SP2024-019: Site Plan for Rockwall KIA

PROJECT NUMBER: SP2024-019
PROJECT NAME: Site Plan for Rockwall KIA
SITE ADDRESS/LOCATIONS: 1790 E INTERSTATE 30, ROCKWALL, 75032

CASE CAPTION: Discuss and consider a request by Mark Fernandez of Lithia C/O Golden Property Development, LLC on behalf of Zohreh Malek for the approval of a Site Plan for an existing New Motor Vehicle Dealership for Cars and Light Trucks on a 5.9613-acre parcel of land identified as Lot 1, Block 1, Rockwall KIA Addition, City of Rockwall, Rockwall County, Texas, zoned Light Industrial (LI) District, situated within the IH-30 Overlay (IH-30 OV) District, addressed as 1790 E. IH-30, and take any action necessary.

DEPARTMENT	REVIEWER	DATE OF REVIEW	STATUS OF PROJECT
PLANNING	Henry Lee	04/24/2024	Needs Review

INVENTORY PKG INTERIOR

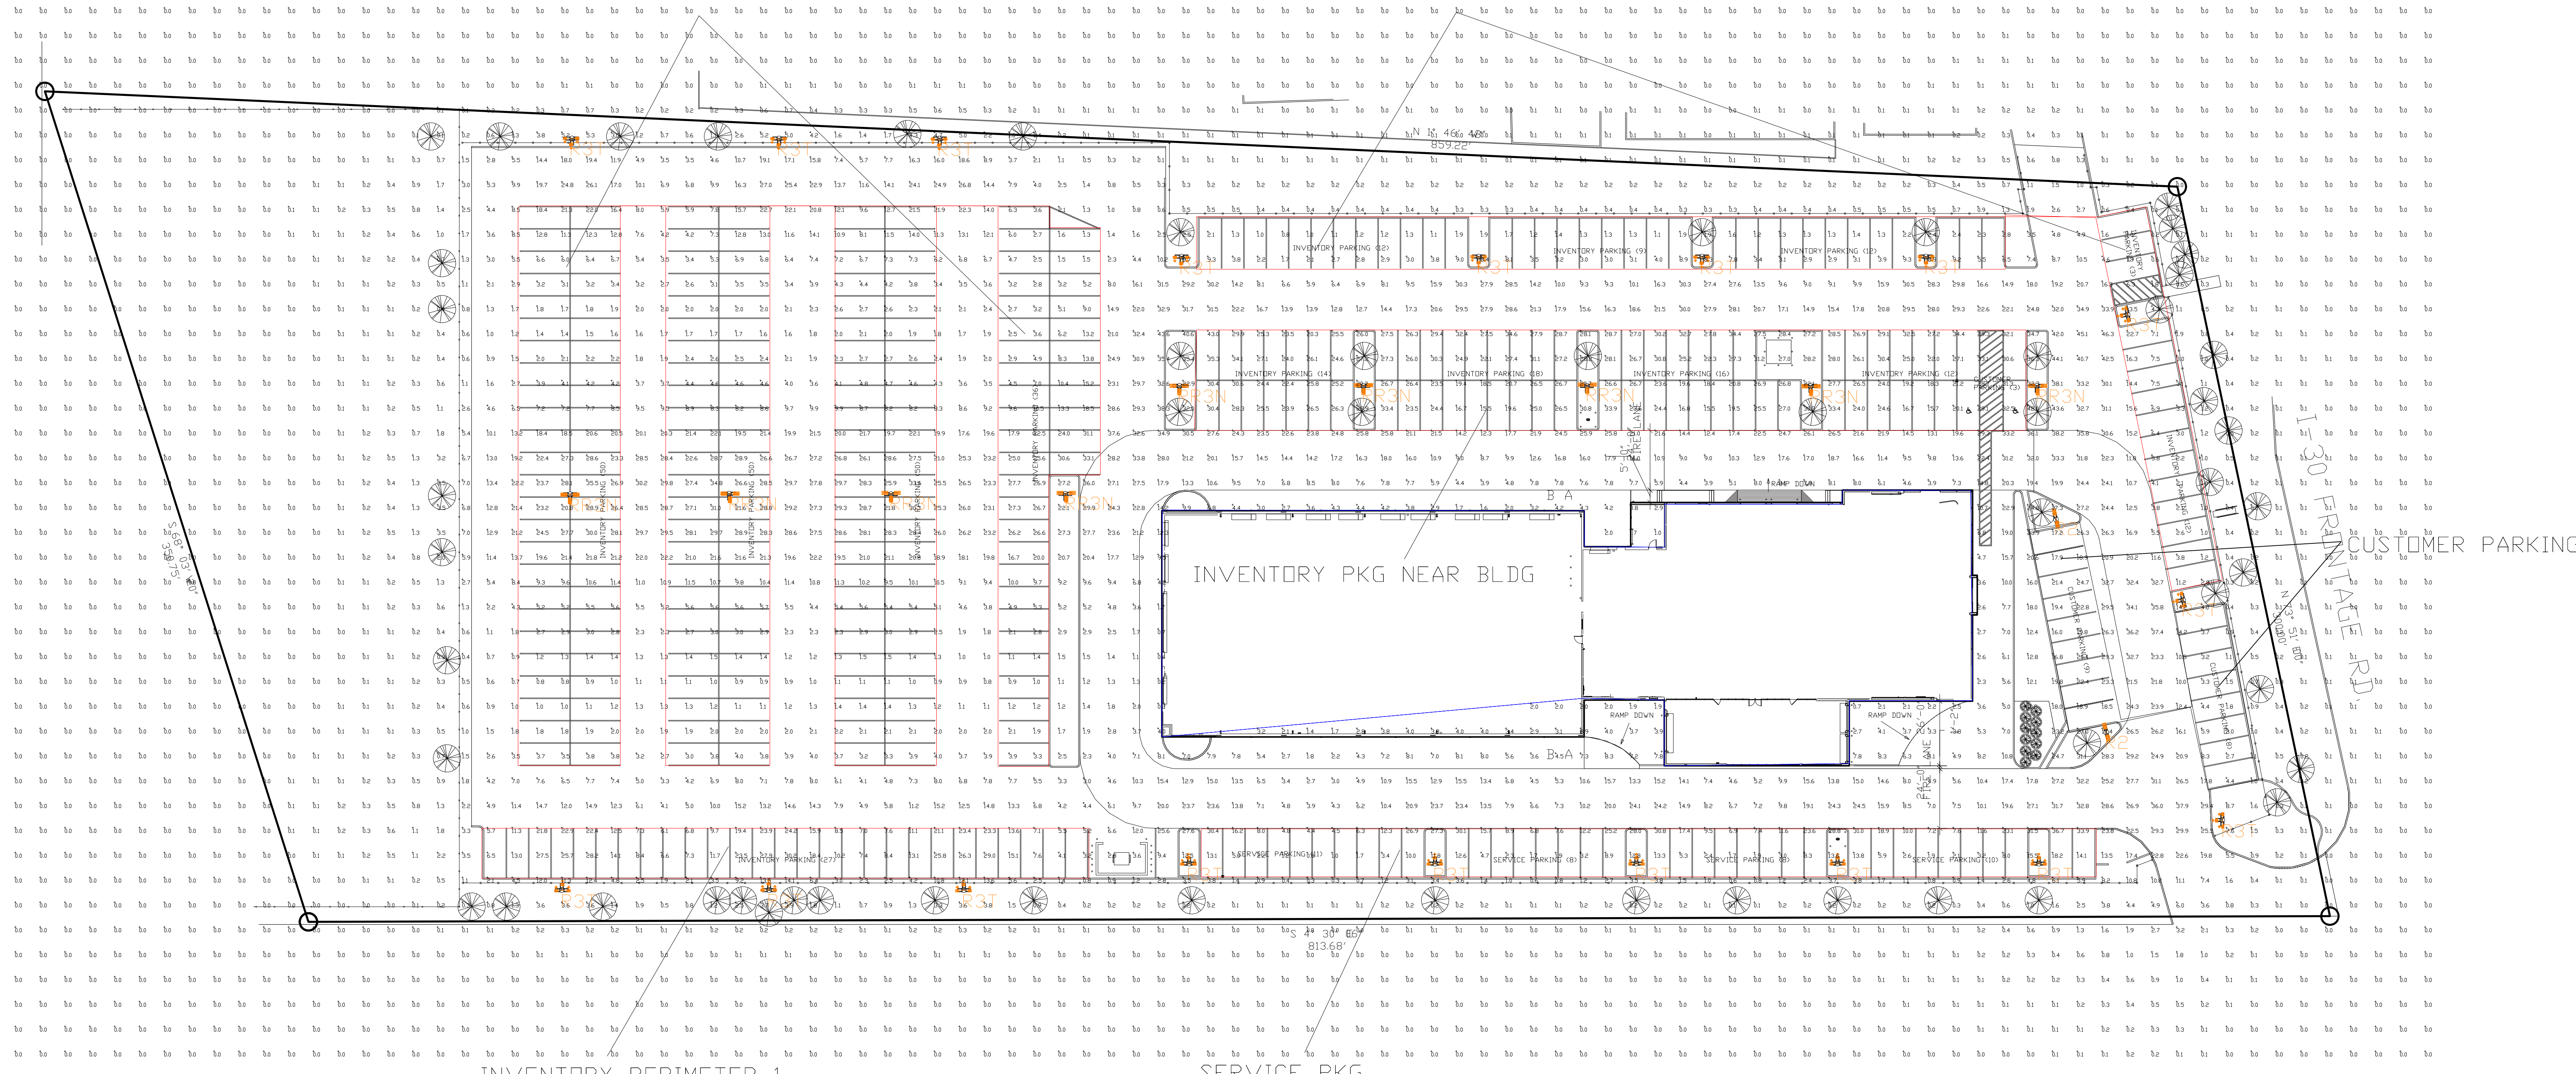
M.9 Photometric Plan.

- (1) Provide the same site data information required in Section 2.1 Site Plan: Miscellaneous and Density and Dimensional Requirements of this checklist.

- (2) Motor Vehicle Dealerships are allowed a maximum of 30 foot-candles in the front yard and a maximum of 20 foot-candles on the remainder of the site. In this case, the photometric plan exceeds these requirements. (Subsection 03.03. E, of Article 07, UDC)

- (5) Please provide lighting cutsheets for all proposed light fixtures. All lighting must be oriented downward and be shielded. (Subsection 03.03, of Article 07, UDC)

1 NOTED SITE PLAN
1" = 32' 0"

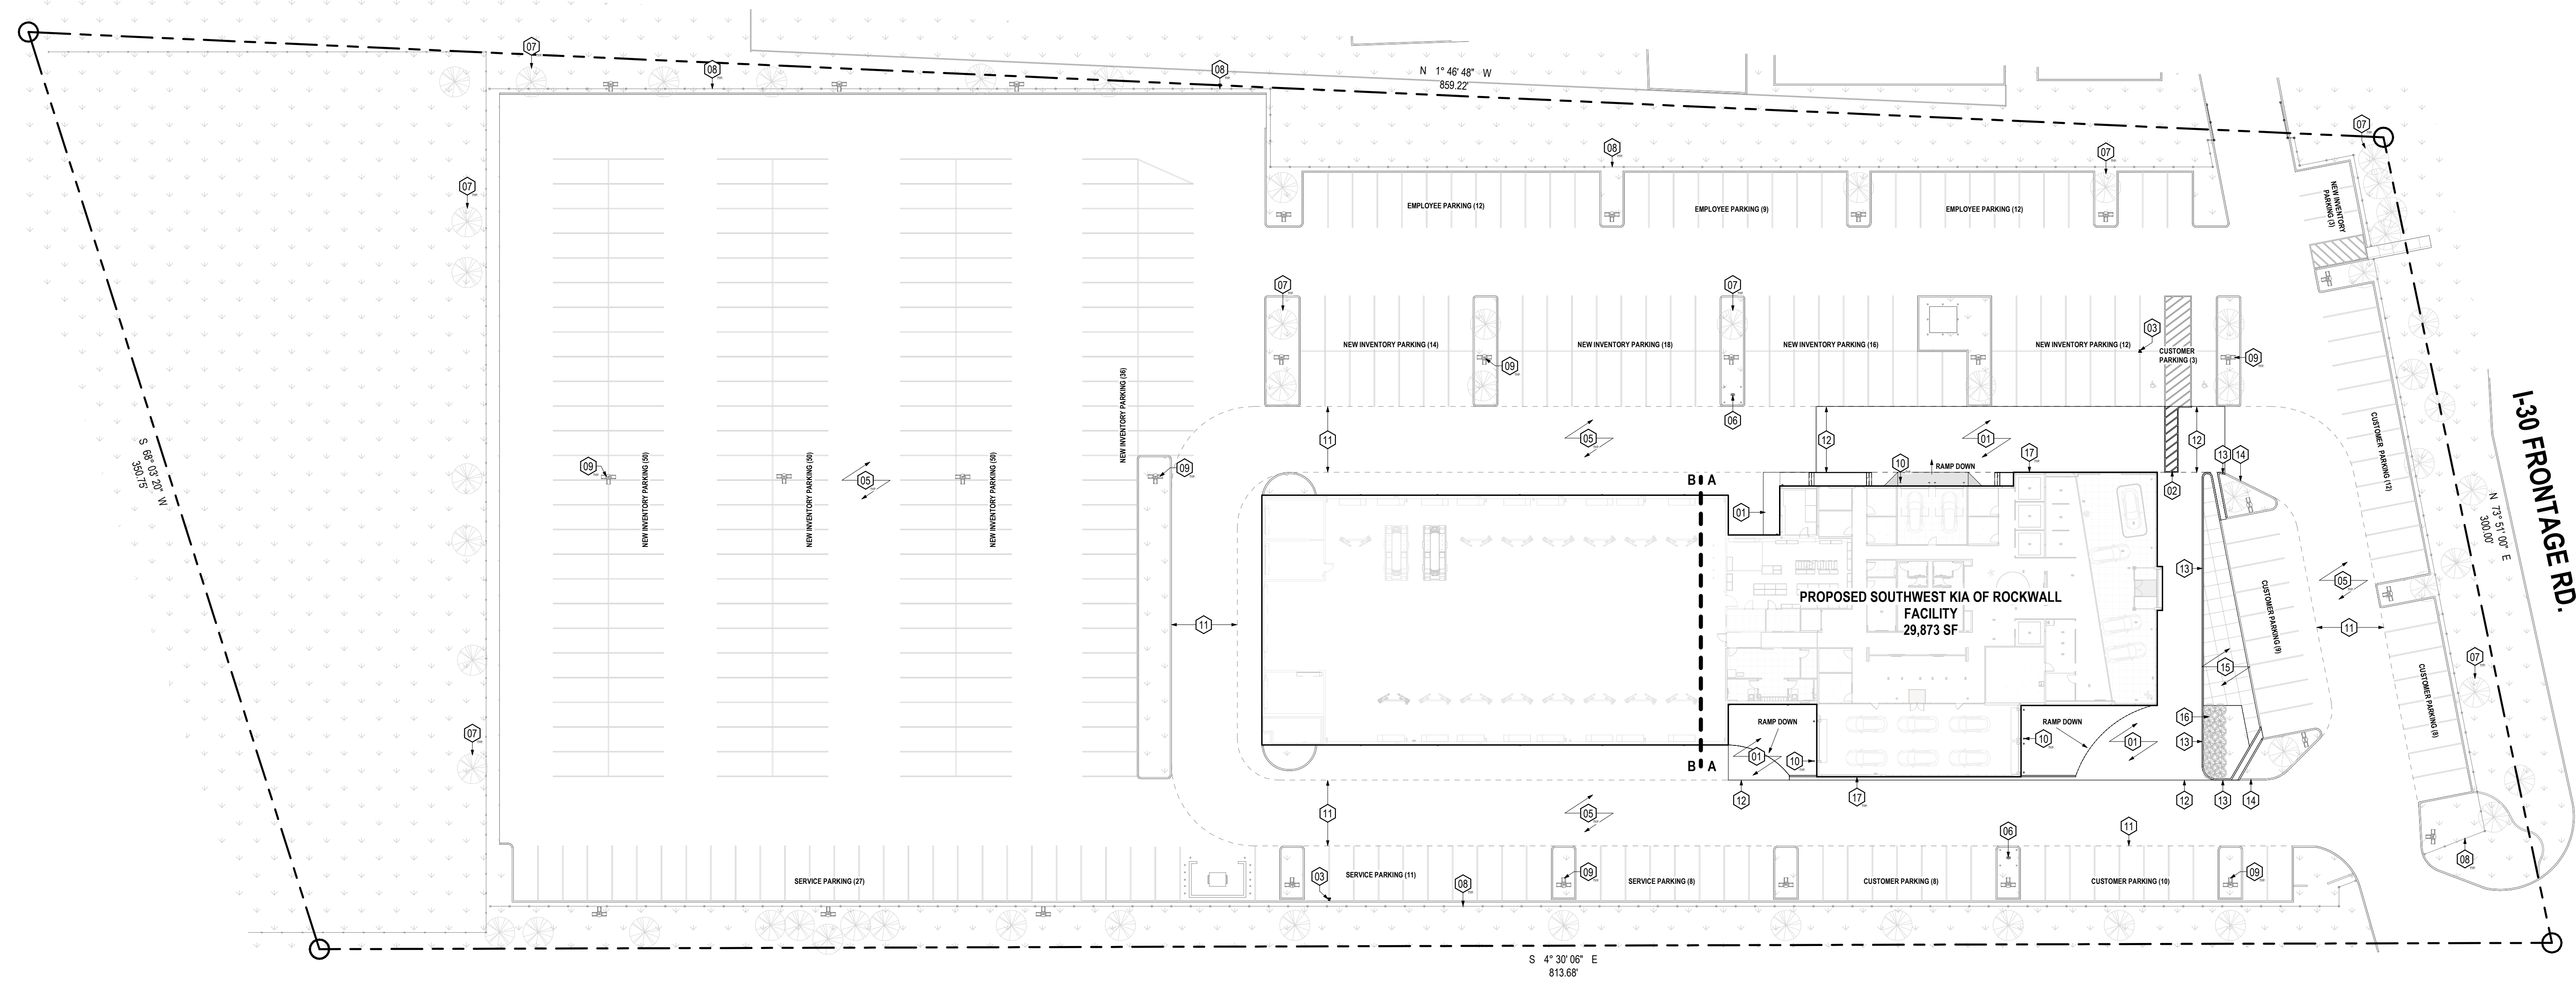
M.6 Site Plan.

- (1) Please provide a numeric and graphic scale, and a vicinity map. (Subsection 03.04. A, of Article 11, UDC)
- (2) Please provide the total lot area in acres and square feet, the dimensions of the building, and the distance between the building and the property line. (Subsection 03.04. A, of

- (5) Please provide a parking table indicating the parking required. There are 45 required parking spaces and you have 47 per the site plan. This just need to be indicated on the site plan. (Subsection 05.01, of Article 06, UDC)

- (6) All signage is covered through a separate permitting process and should not be shown on the site plan or building elevations. (Subsection 06.02. F, of Article 05, UDC)

- (7) Please indicate any new or proposed fencing. Indicate the height and material. (Subsection 08.02, of Article 08, UDC)
- (8) Is there any proposed pad/ground mounted utility equipment? If so, please delineate it and provide the subsequent screening on the landscape plan. (Subsection 01.05. C, of Article 05, UDC)

- (9) Is there any roof mounted utility equipment? If so, please crosshatch it on the building elevations and provide the subsequent screening. As a note, all units must be screened from all Right-of-Way and adjacent properties. In this case, the units shall not be visible from I-30. (Subsection 01.05. C, of Article 05, UDC)
